# Subregional RTEP Committee – Western FirstEnergy Supplemental Projects

August 16, 2024

## Abbe – Medina 69 kV Line Customer Connection - s2056 Scope Change

## Abbe – Medina 69 kV Line Customer Connection - s2056 Scope Change

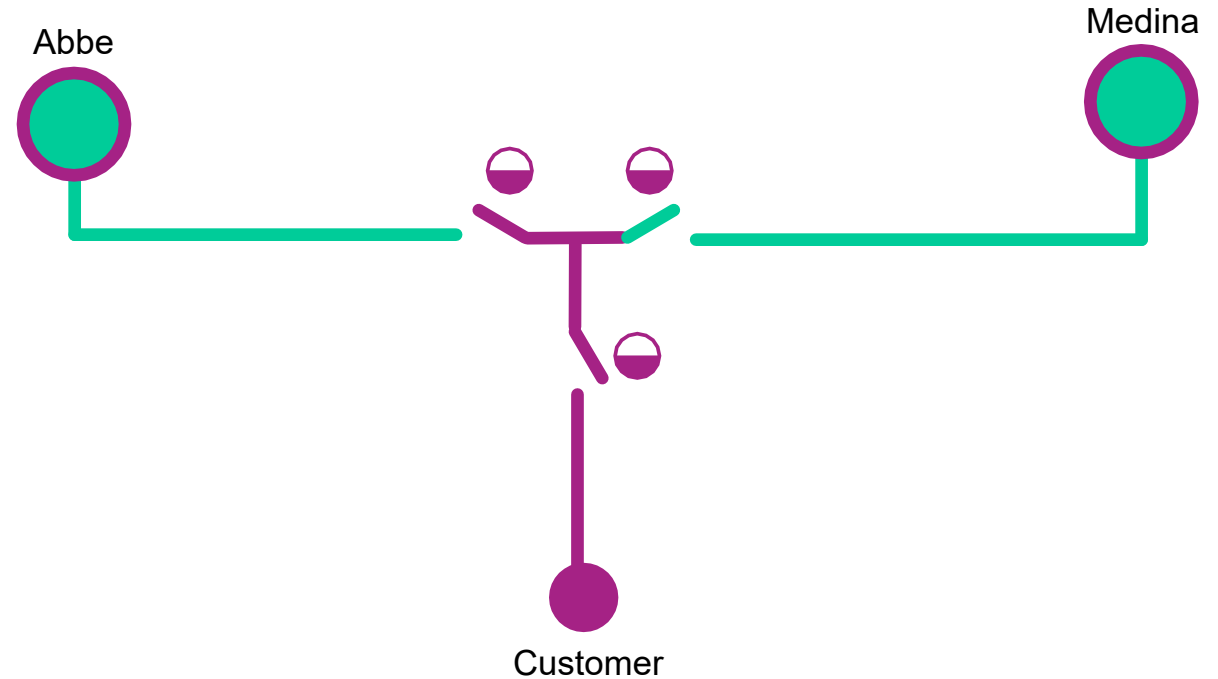
*Reason for Scope Change:* Ohio Edison unable to secure property for the new facility. Through community engagement, Ohio Edison was able to secure a property approximately 0.2 miles from the originally presented customer location.

- Tap the Abbe-Medina 69 kV line approximately ~~10.9~~ 11.1 miles from Medina substation and build one 69 kV span to the proposed customer substation
- Install ~~two (2)~~ one (1) 69 kV in-line switches with SCADA control on either side of the new tap connection
- ~~Remove switch A-259 from structure # 24 at Marks road south of the proposed customer substation~~ Install SCADA capabilities to existing main-line switch
- Install one tap-line SCADA controlled switch.
- Adjust relay settings at Abbe and Medina substations.
- Install revenue metering.

**Estimated Project Cost:** ~~\$1.4 M~~

\$0.9 M

**Projected In-Service:** ~~12/31/2020~~

12/31/2024
